TECH BULLETIN 135

Bolt hole changes to crankcase and bearing covers for all 25 and 28 Frame plunger and piston pumps

99TCH135 Rev B 1/21

New Crankcase Style

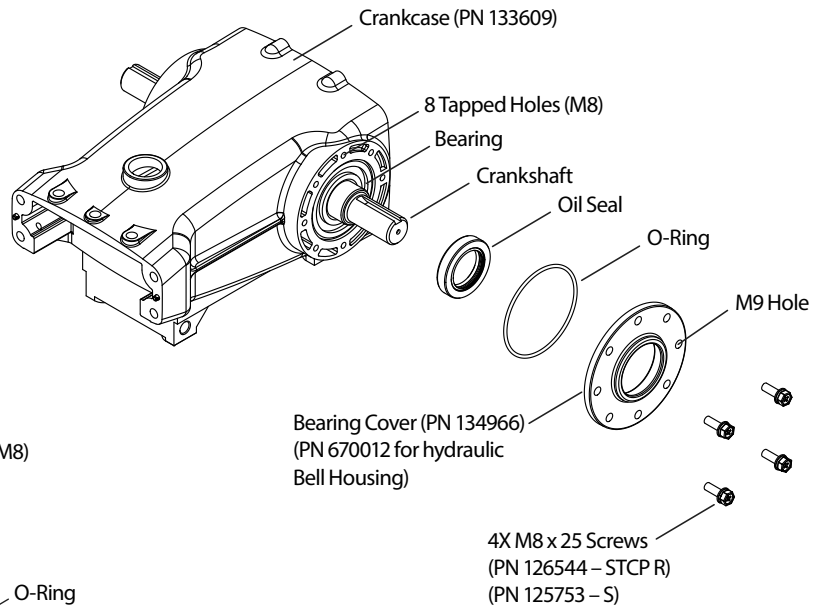
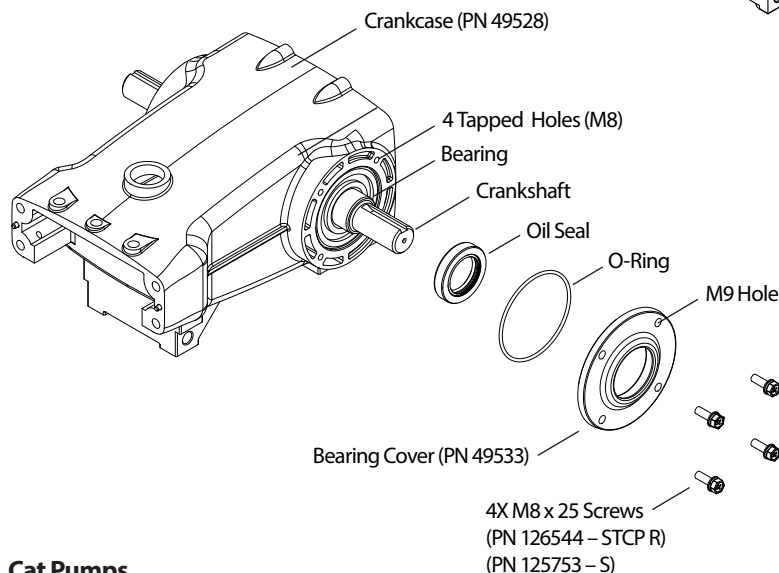
Changes have been made to the crankcase and mounting hardware to better support the weight of direct-drive hydraulic bell housings. This affects all 25 and 28 frame plunger pumps with date codes/serial numbers after August 2020.

- Crankcase bell housing mounting bolt holes number increased from four (4) to eight (8) to better distribute weight of hydraulic motor on crankcase.
- Bell housing mounting bolt quantity changed from four (4) M8 to eight (8) M8 bolts.

- Crankcase has eight (8) tapped holes on each side for hydraulic bell house mounting.
- Bearing cover has eight (8) through holes, but only supplied with four (4) M8 bolts.
- No change to the shaft protector.
